Economic and Social Council

Working Party on the Transport of Perishable Foodstuffs

Amendments to and clarifications of ATP annex 1, appendix 2, paragraph 20 and supplements to annex 1, appendix 2, of the ATP Handbook*

Transmitted by the Government of the Russian Federation

Fig. 2

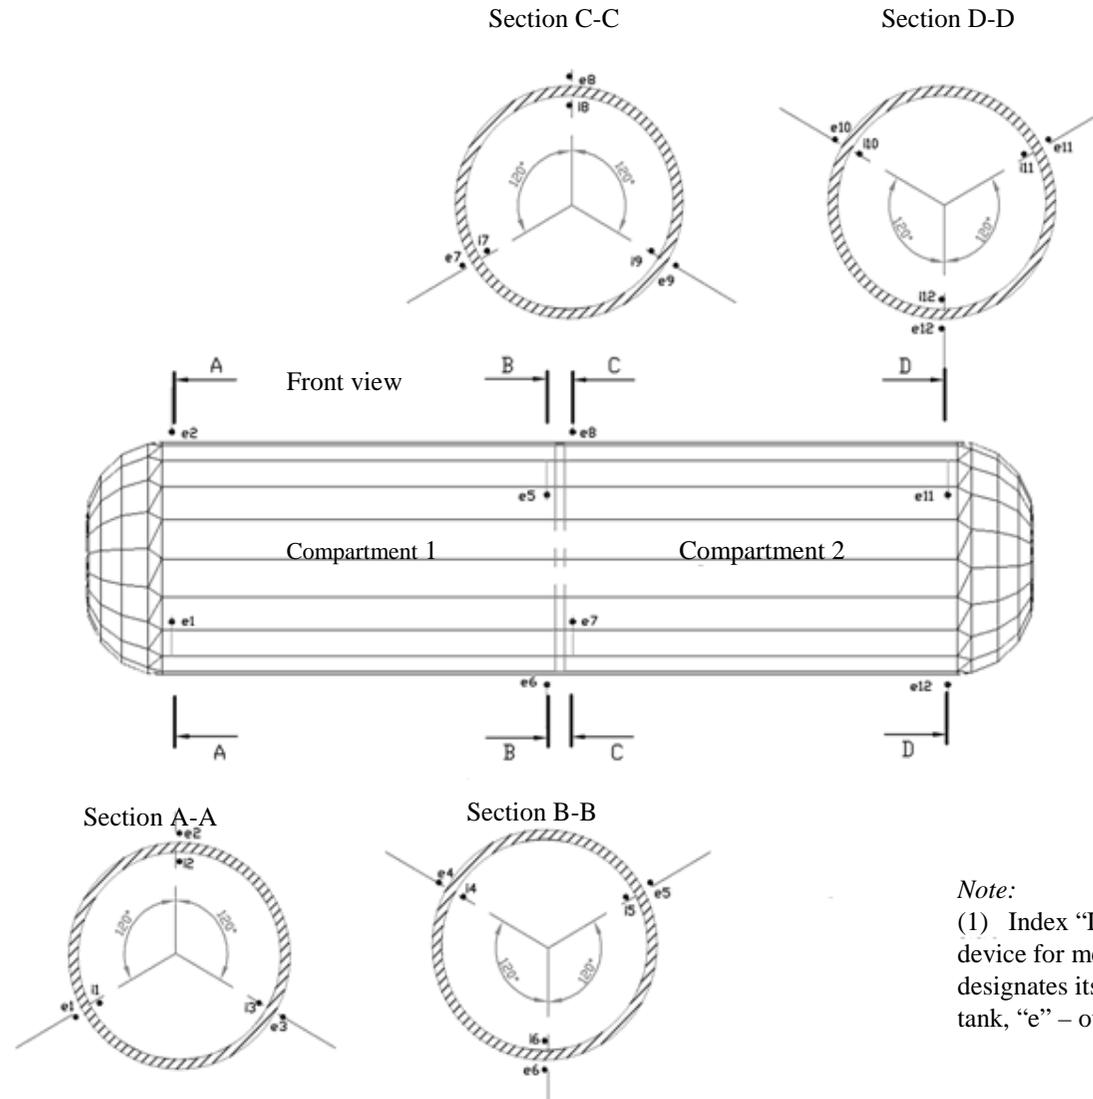
Supplement ATP Handbook annex 1, appendix 2, with the layout of the placement of air temperature measuring devices inside and outside tanks with two compartments (figure 2, as renumbered) during tests aimed at determining the K coefficient.

The layout of the placement of air temperature measurement devices inside and outside tanks with two compartments is shown in figure 2.

13. The new figure 2 is included below.

(b) *If the tank has two compartments, the measurements shall be made at least at the following points:*

- *Near the bottom of the first compartment and near the common partition in the second compartment – at the extremities of three radiuses forming 120° angles, one of the radiuses being directed vertically upwards*
- *Near the bottom of the second compartment and near the common partition in the first compartment – at the extremities of three radiuses forming 120° angles, one of the radiuses being directed vertically downwards*
